**AGENDA
PLANNING BOARD
MARCH 9, 2020**

**TACKLE PARTNERS, LLC; 37
SPENCER ST (Tax Map 78, Lot 5),
zoned LD**

Staff Memorandum – #PB2020-09-SPA

Application Type: Site Plan Review of conversion of existing industrial/commercial building to a multi-family dwelling with 25 residential units

C0.0
19327.01

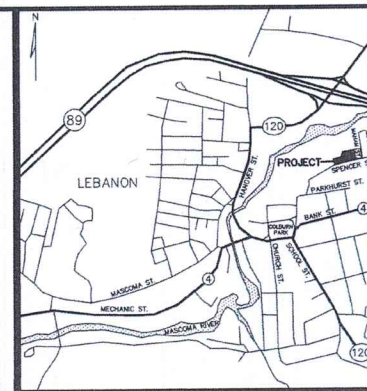
- d) Remove all references to the "CBD" or "CB District" and/or change references to "LD" or "LD District" (see Sheet C0.0 and C1.1).
 - e) Revise Sheet SL-1 to use the correct site plan (including the removal of the warehouse at the northwest corner of the building), to remove parking space numbering, to add additional lighting along the western side of the building as appropriate, to remove depiction of landscaping, and to update or remove the use labels on the building (which are inaccurate).

DRAWING TITLE:
EXTERIOR PHOTOMETRIC POINT CALCULATION

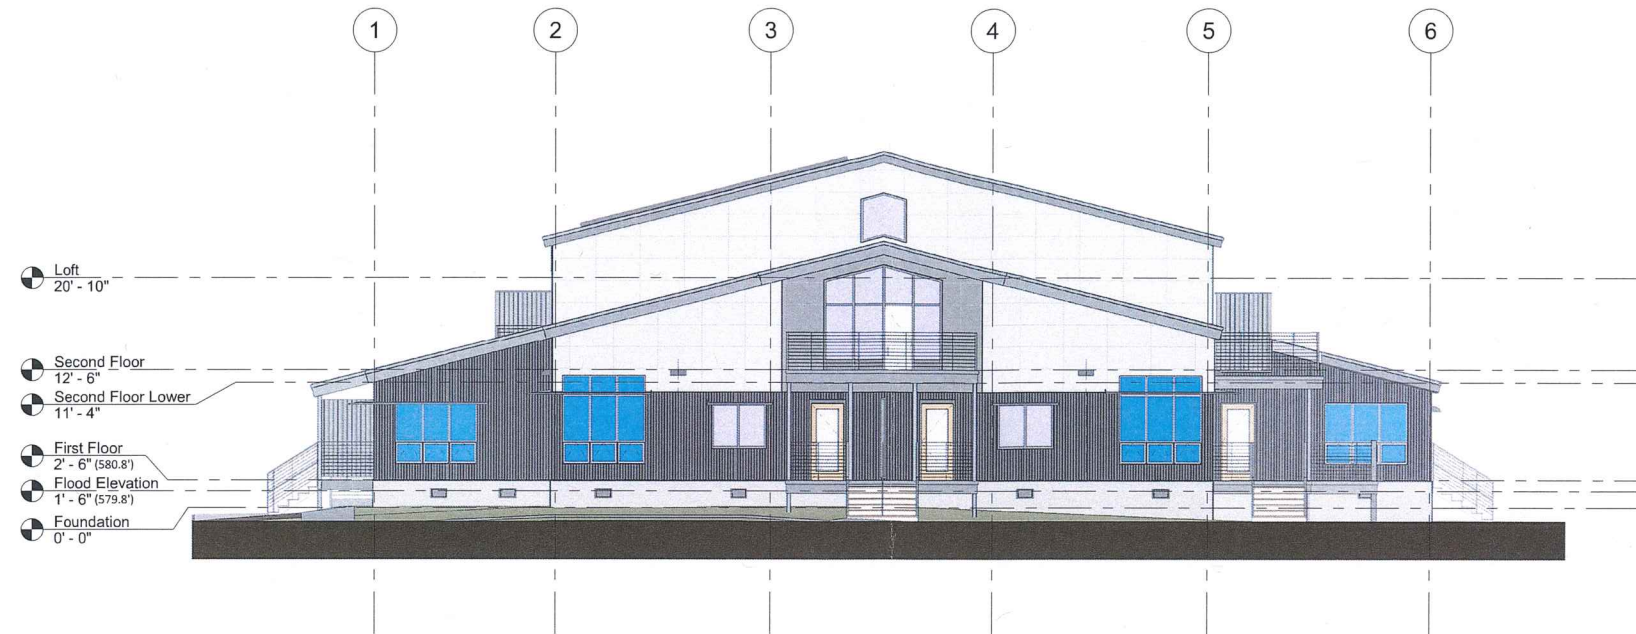
Staff recommends that the applicant revise and update the lighting plan utilizing the correct site plan (an older version of the site plan – which includes the warehouse at the northwest corner of the building now proposed to be removed – appears to have been used to prepare the lighting plan), to add additional lighting along the western side of the building as appropriate, to remove parking space numbering, to remove the depiction of landscaping (which is inconsistent with what is depicted on the landscaping plan), and to update or remove the use labels on the building (which are inaccurate).
